Re: Harold D. Thompson Regional Water Reclamation Facility (HDTRWRF)
Lower Fountain Metropolitan Sewage Disposal District (LFMSDD)

Submittal No.:	03200-009
Date of Submittal:	June 6, 2011
Title:	Foundation Plan & Base Slab Reinforcing for Secondary Clarifiers, Drawings P14, P15
Specification Section:	03200
Manufacturer:	Dalco Industries, Inc.

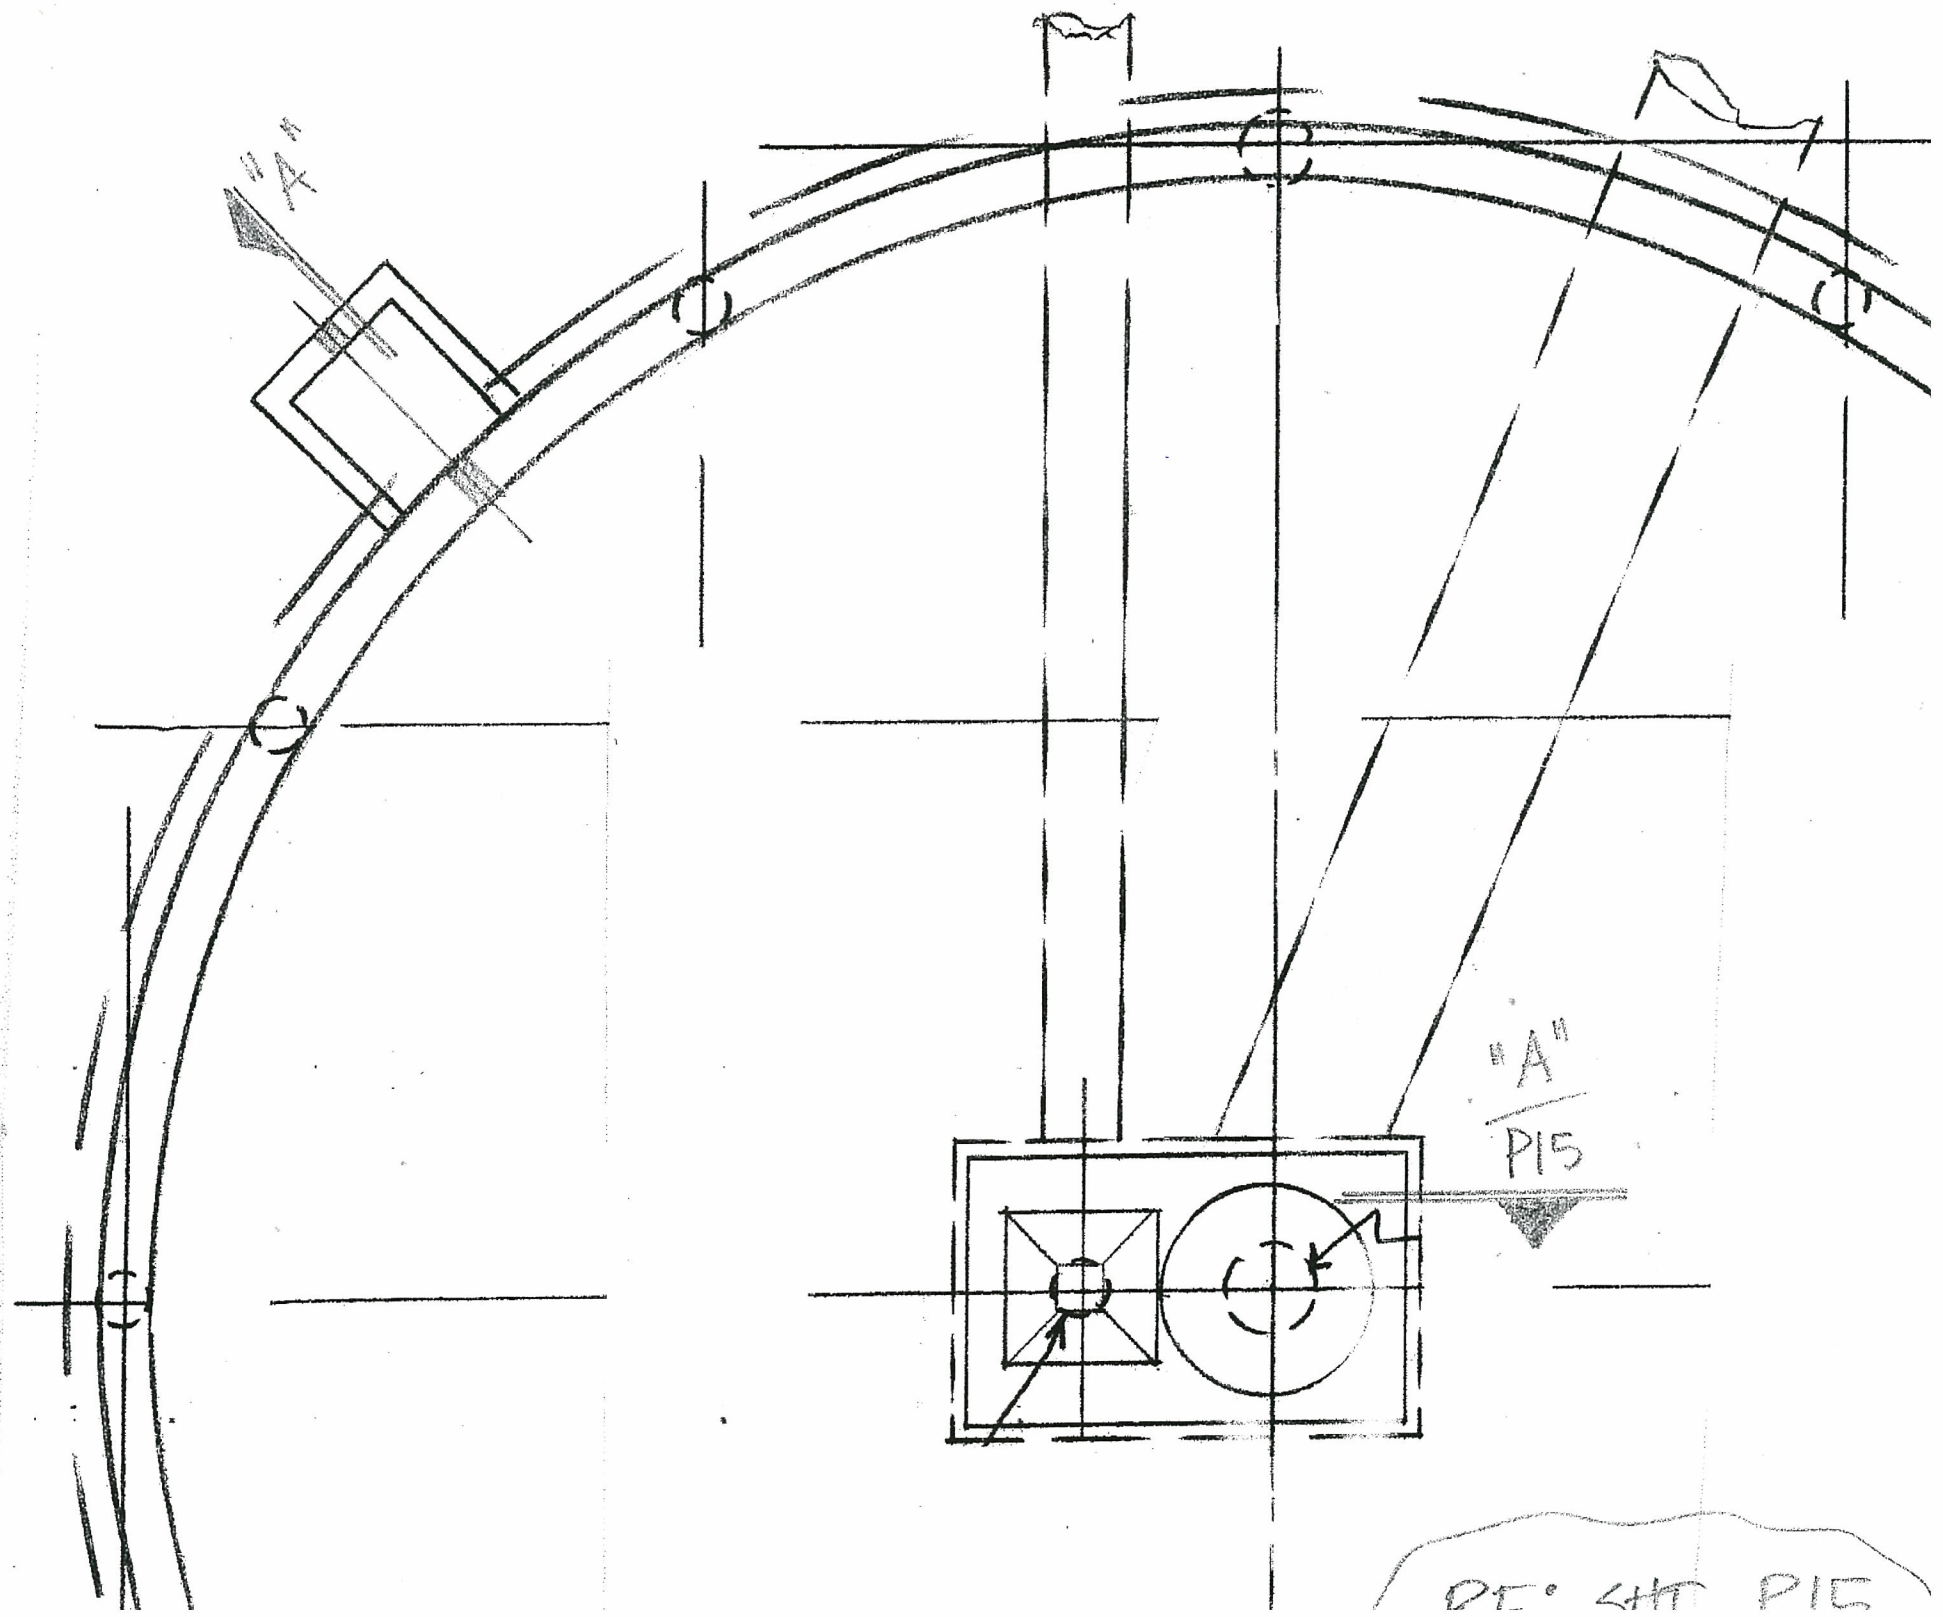
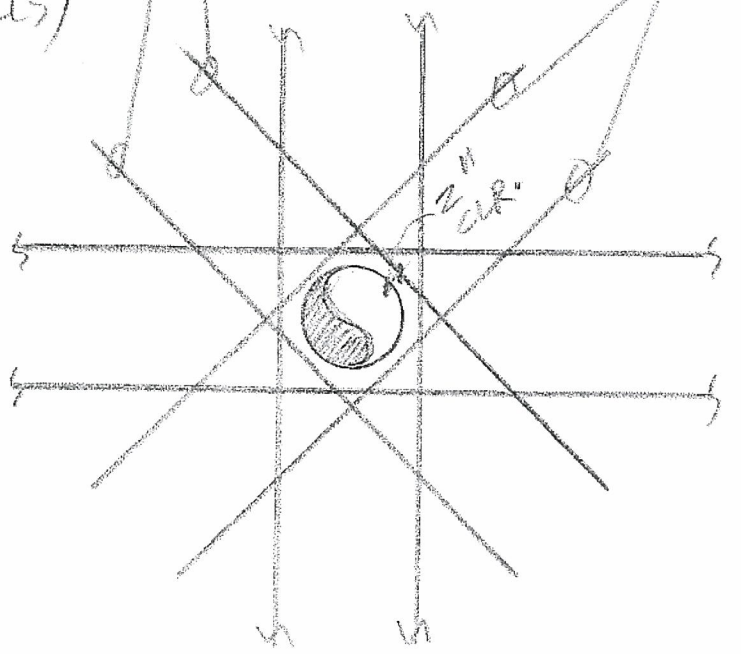
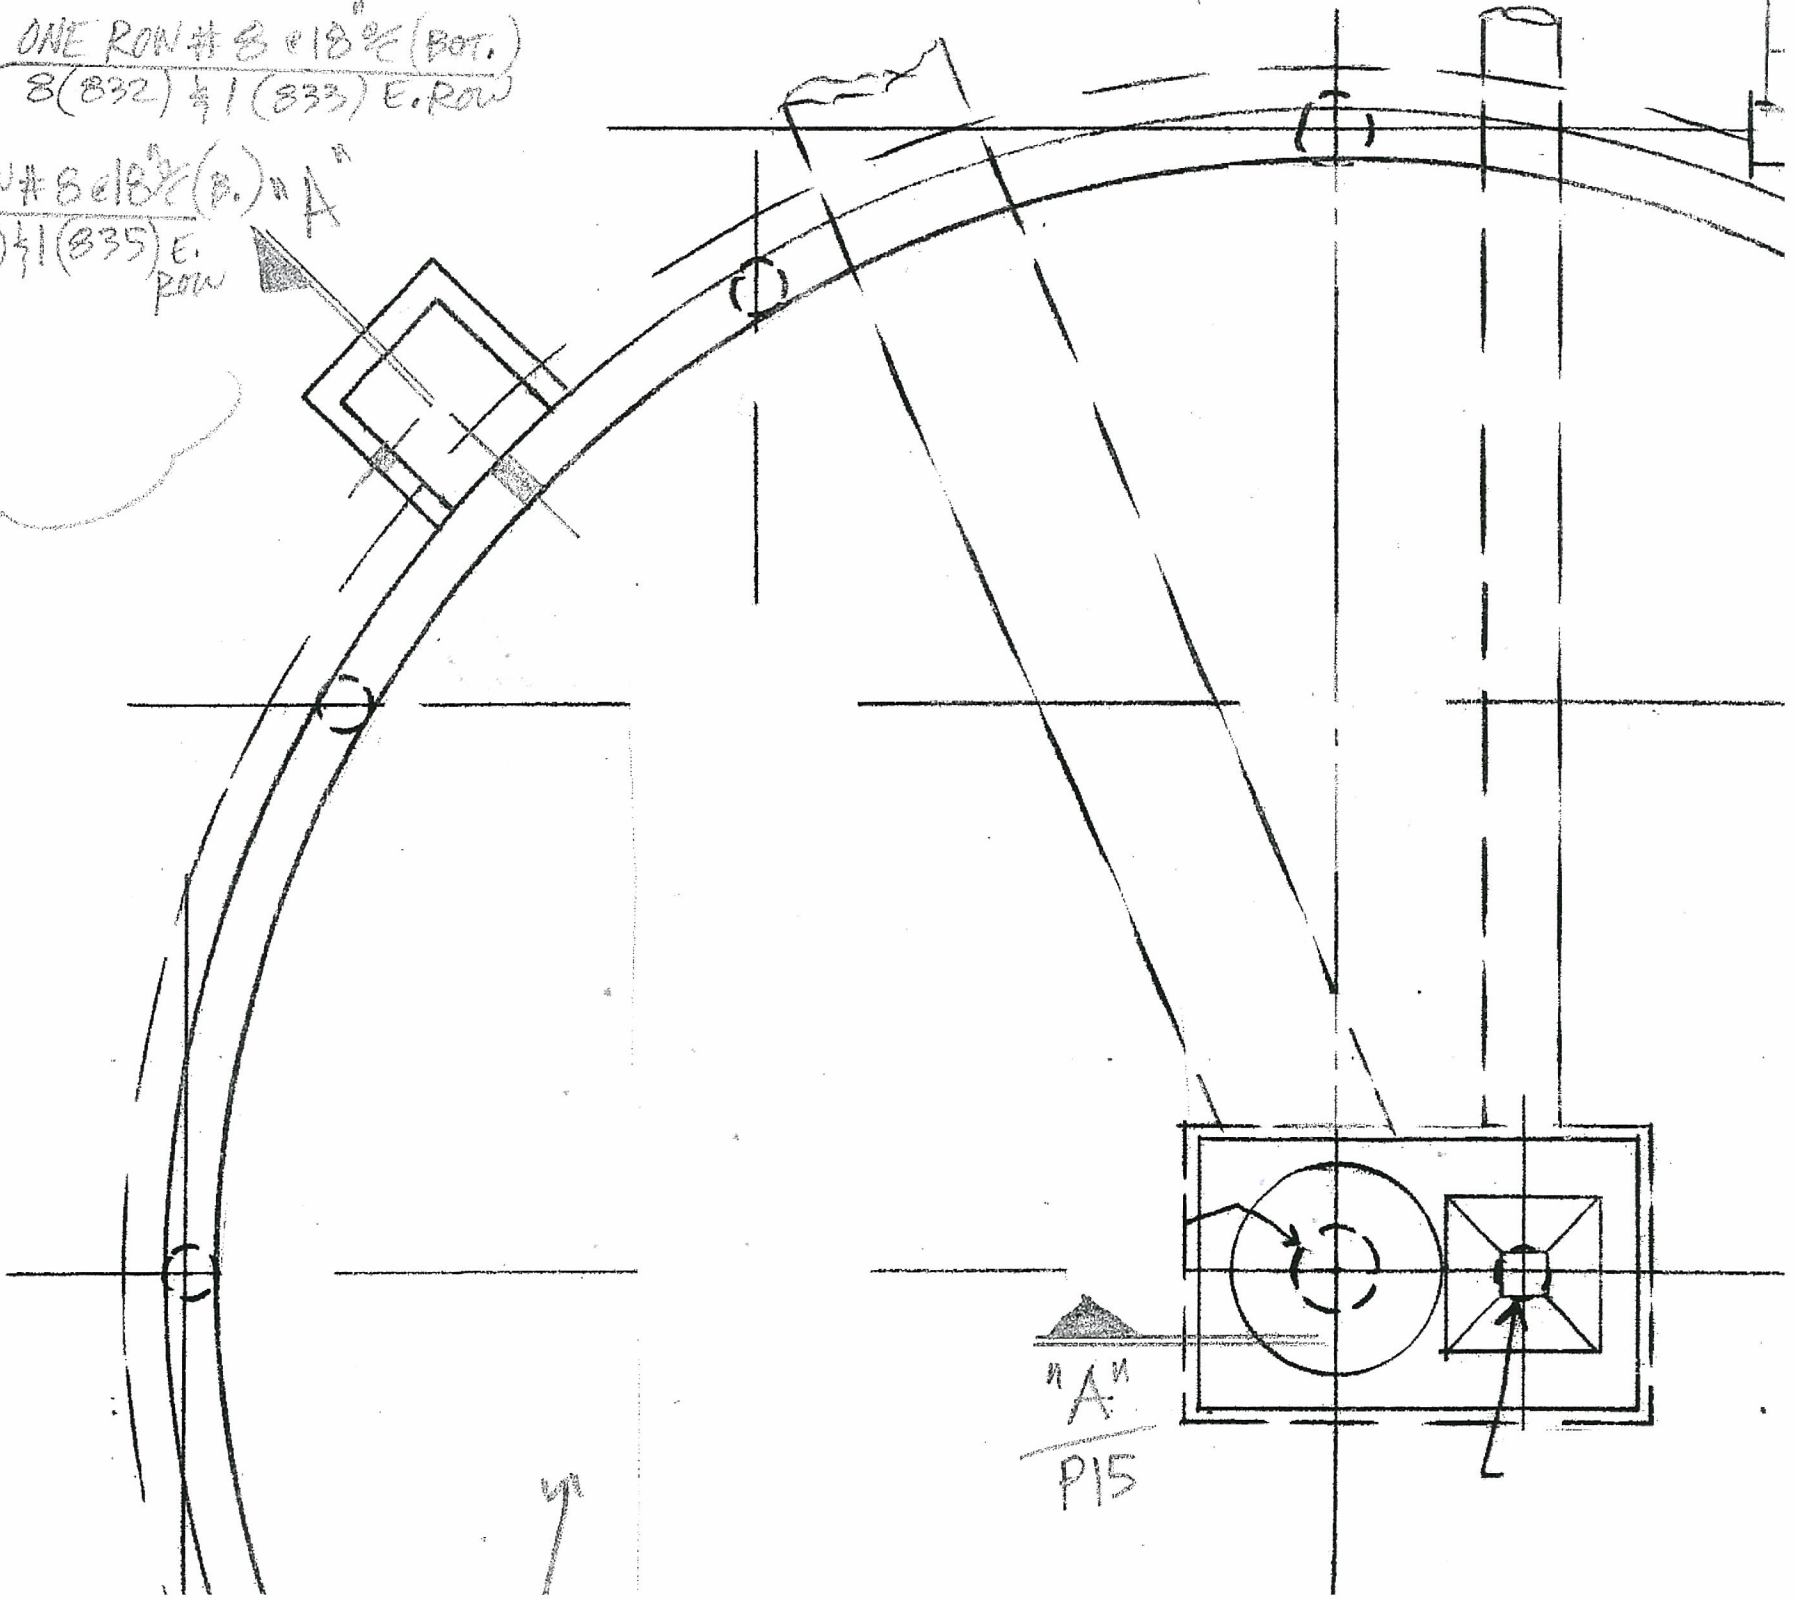
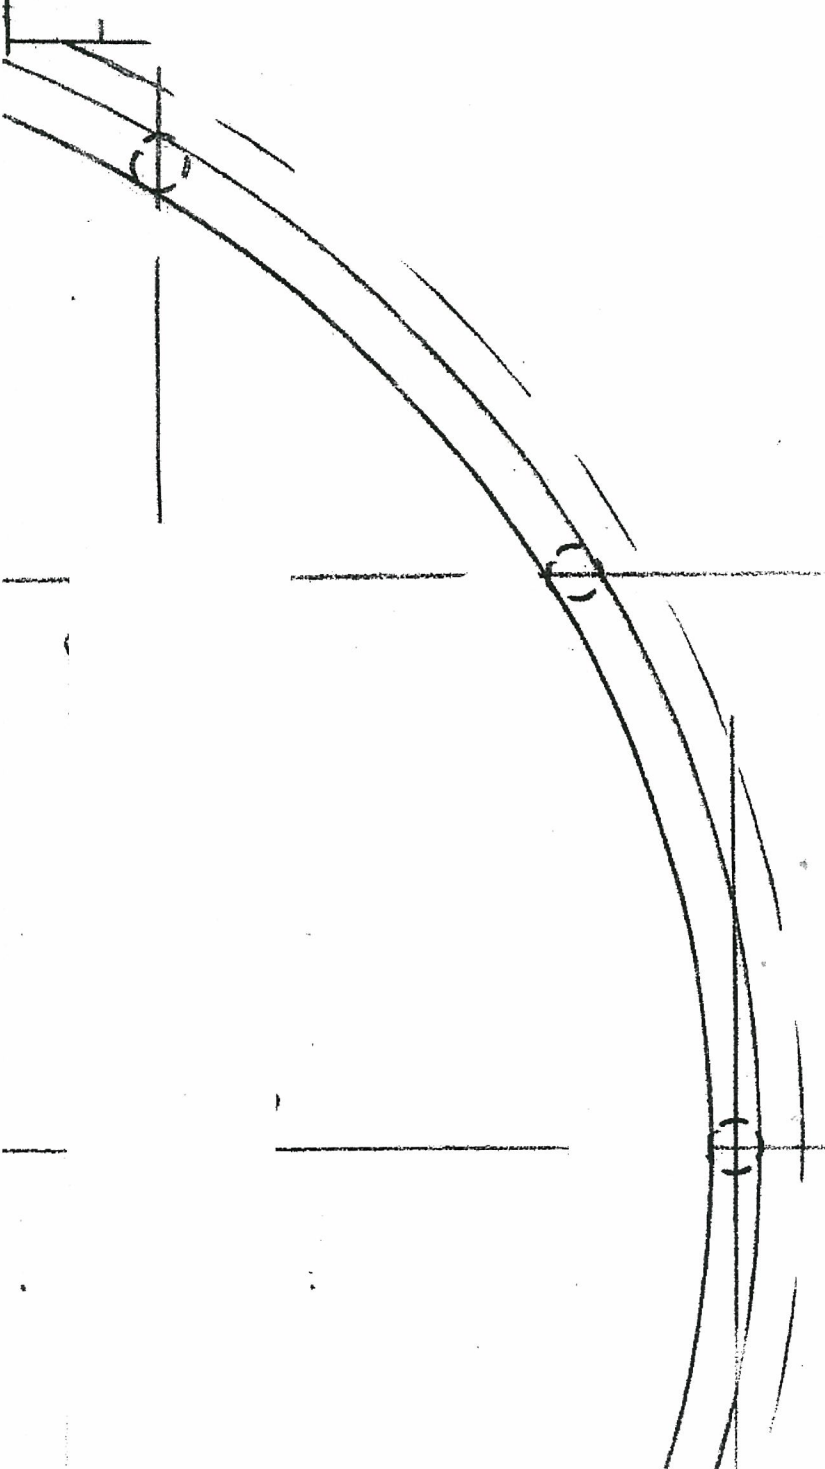
PLEASE ADVISE IF COUPLERS ARE AN OPTION

OK, SEE RFI #10

(X3) ? X4
VERIFY TOTAL # OF
PIPE PENE

REVISE BASED ON "B"- "C" / P-15

OK, SEE
RFI #10

1. Included with this letter are scanned copies of the submittal drawings P14 and P15 with handwritten comments in **red**. As these comments are relatively minor in nature, a complete resubmittal for these items is not required at this time. Please ensure that all handwritten comments are satisfactorily addressed prior to fabrication, delivery and placement of the reinforcing steel.
2. Please refer to RFI-010 delivered to WGCC on June 13, 2011 regarding dimensional information for dowels associated with the Form Saver installations.
3. Please closely coordinate with the clarifier equipment supplier to ensure that all required equipment anchors and/or embedments are installed in strict accordance with the supplier's instructions.
